**Pediatric Clinic 2022
Neshoba General
Philadelphia, MS**

Addendum No. 3
September 9, 2022

This addendum forms a part of the contract documents and modifies the original plans and specifications dated July 14, 2022.

sheet no.
E-1P

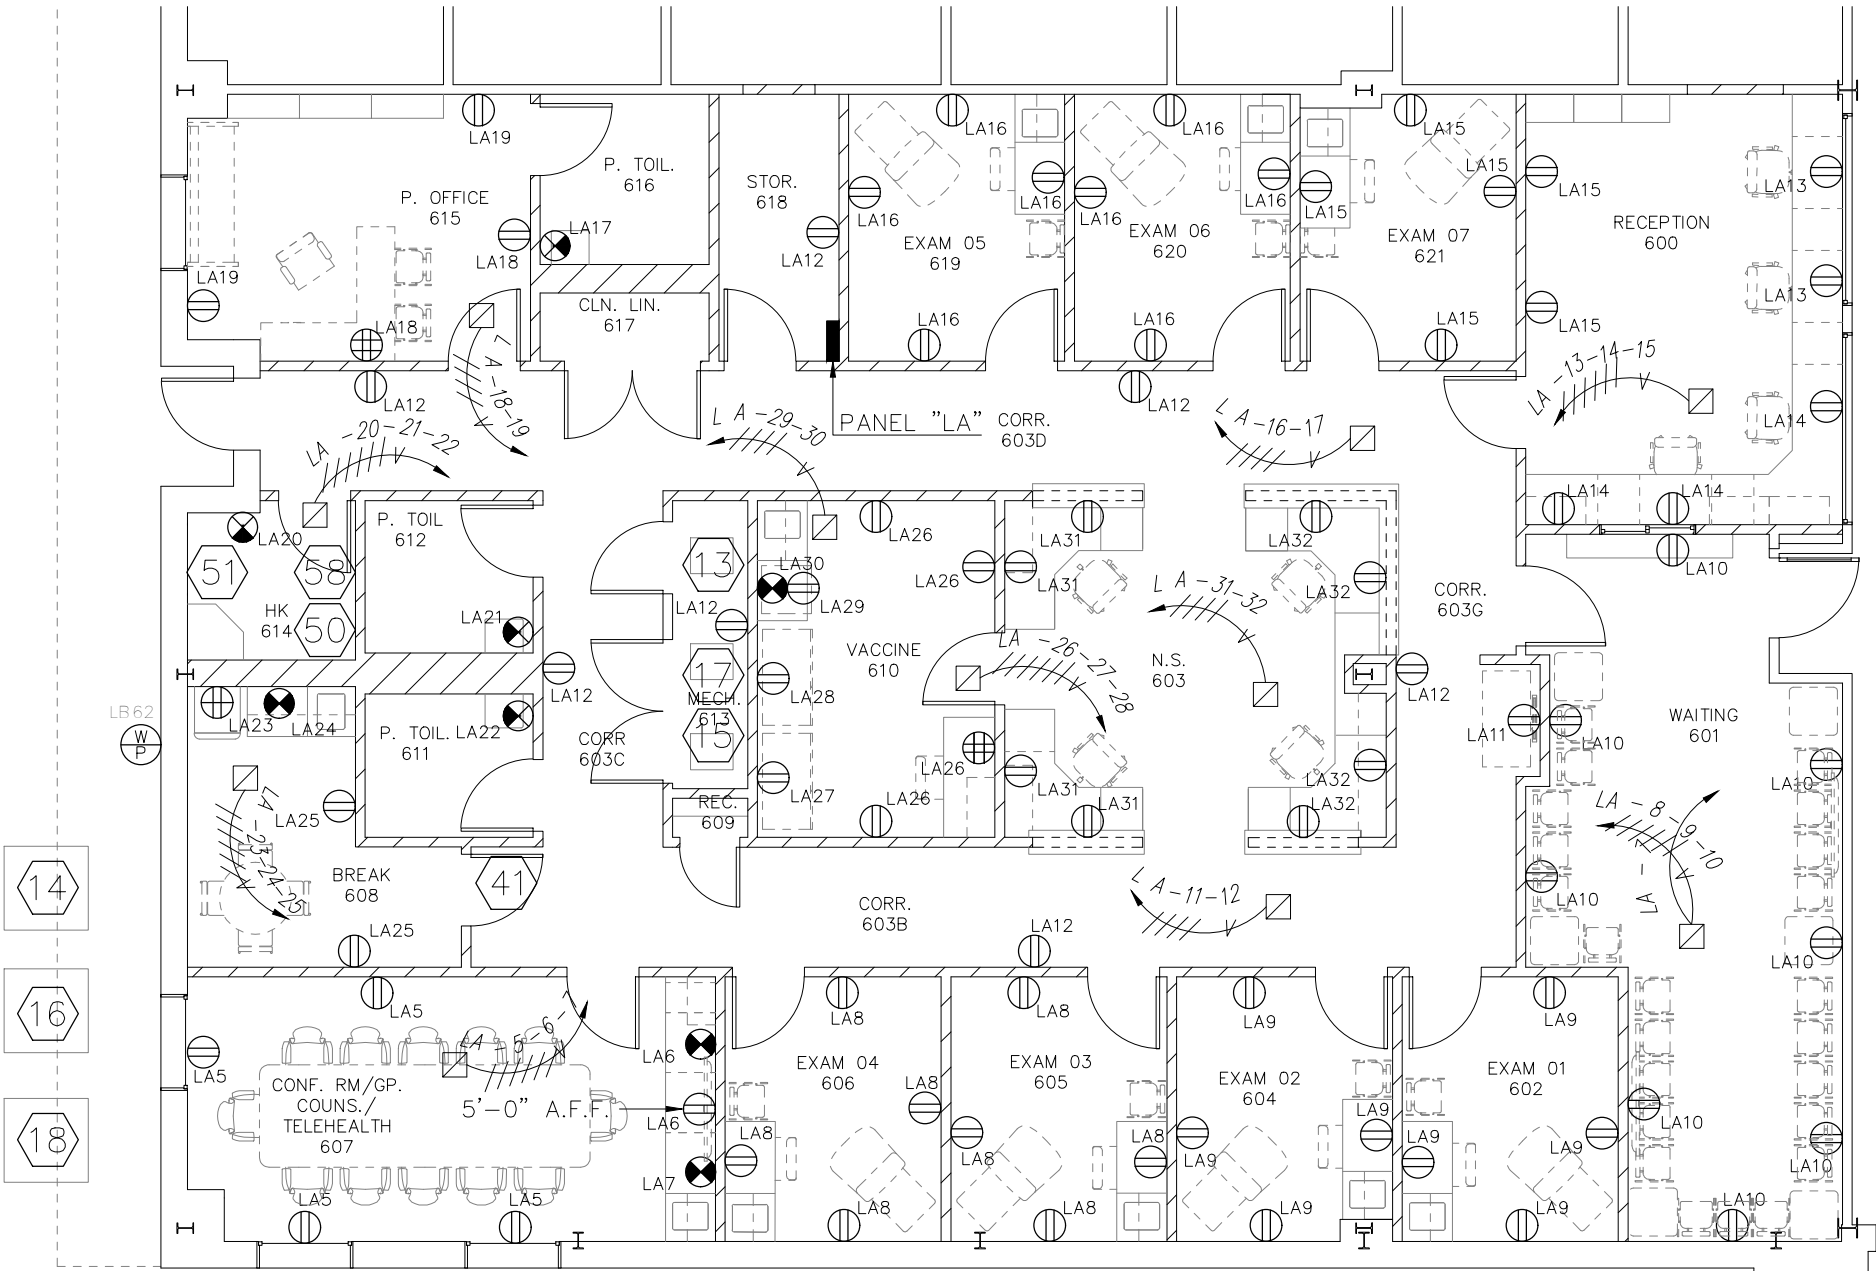
Item 3.4: Sheet E-1, Partial Floor Plan – Suite 600 - Power

Note: See attached sheet E-1P for revised/additional receptacle locations.
